**PLAN COMMISSION MEETING
MONDAY, NOVEMBER 21, 2022 - 6:00 PM
COUNCIL CHAMBERS, CITY HALL**

STAFF REPORT
To Lake Geneva Plan Commission
Meeting Date: November 21, 2022

Subject: SITE PLAN REVIEW– 910 Maytag Road – Renovations to existing structure

- **Uhler Residence 910 Maytag Road**, prepared by **ALA Architects and Planners Inc.**, sheets A000, A011-A012, A100-A102, A200-A203., A300-A301, E101-E102, dated 08-10-2020 last revised 10-06-2022.

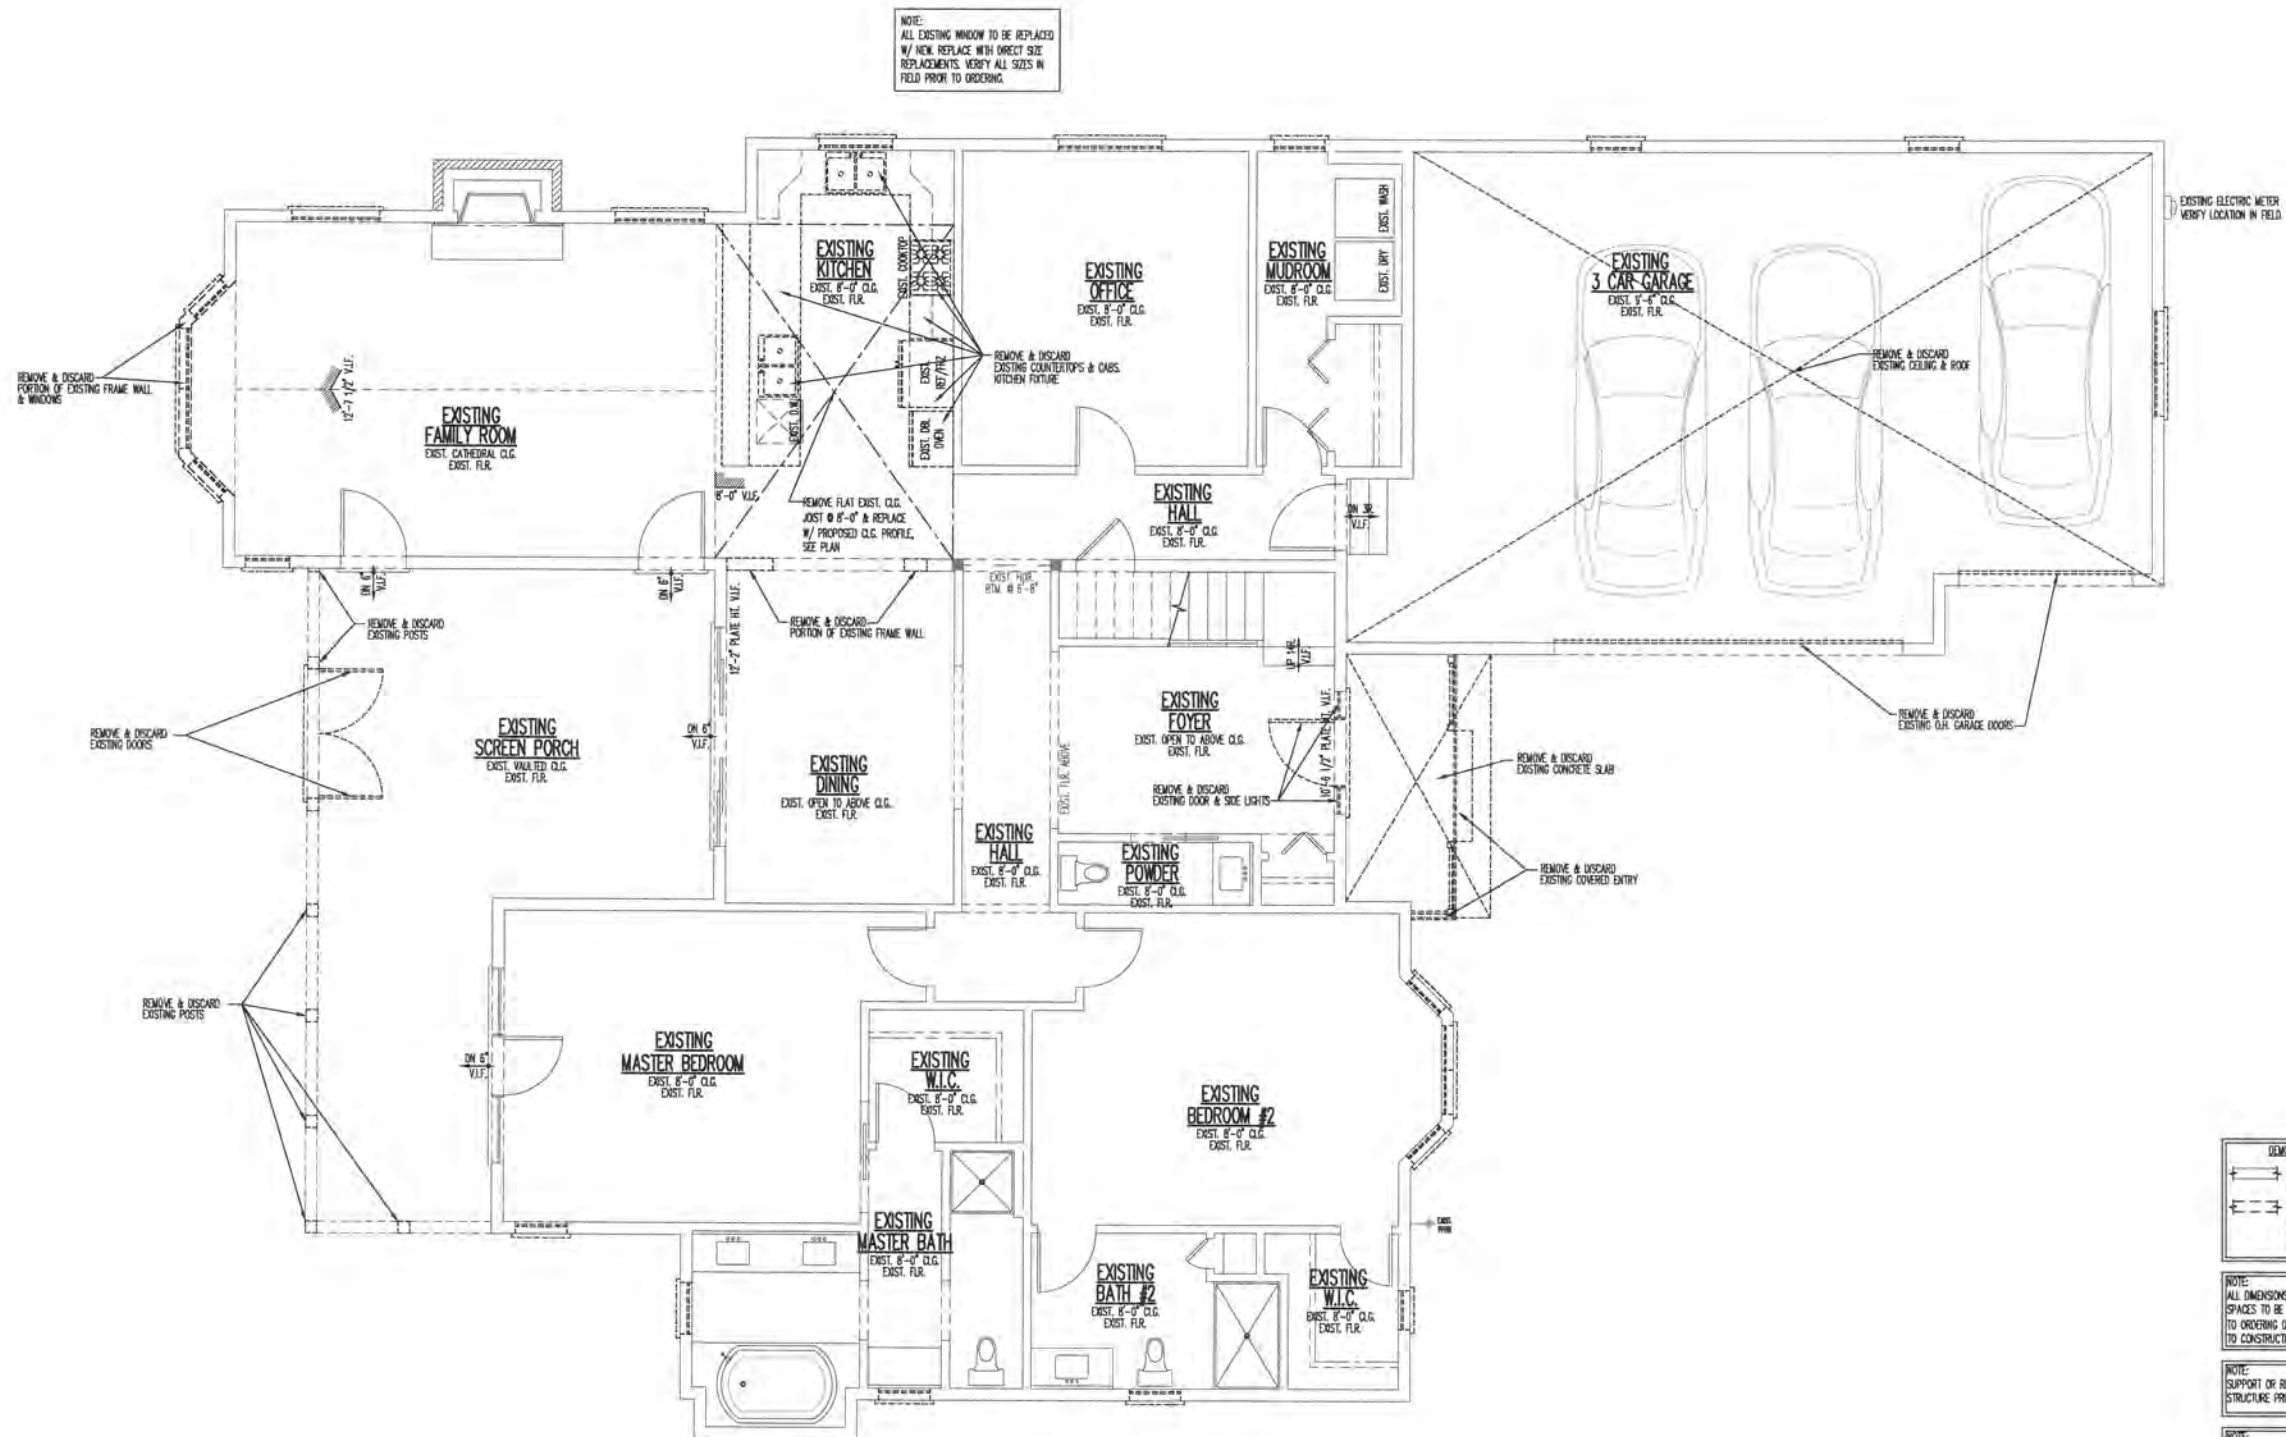
1. The conditional use application proposes an increase in impervious of 308 SF within the lakeshore overland district. Stormwater quality provisions of the Ordinance shall be addressed for new impervious surface. One option is to construct a raingarden, consistent with WDNR Technical Standard 1009 for 100% runoff volume control for the new impervious surface proposed. See Technical Guidance attached.
 - a. Calculations shall be provided to show that rain garden sizing meets Technical Guidance 1009.
 - b. Rain garden dimensions, elevations, ponding depth and other design parameters shall be shown on the site plan. This information includes site grades showing stormwater can access and pond within the proposed rain garden.
 - c. A cross -section of the raingarden shall be provided.

- d. The construction plans must include maintenance activities as outlined in the technical standard. The property owner is responsible for installation and maintenance of the raingarden consistent with Technical Standard 1009.
- 2. A sedimentation and erosion control plan is required.
 - a. A stabilized construction entrance and detail shall be designated on the construction plans.
 - b. Silt fence downstream of the proposed improvements is required. A detail of appropriate silt fence installation shall be included on the site plan.
 - c. Restoration of disturbed areas shall commence as soon as possible after construction.
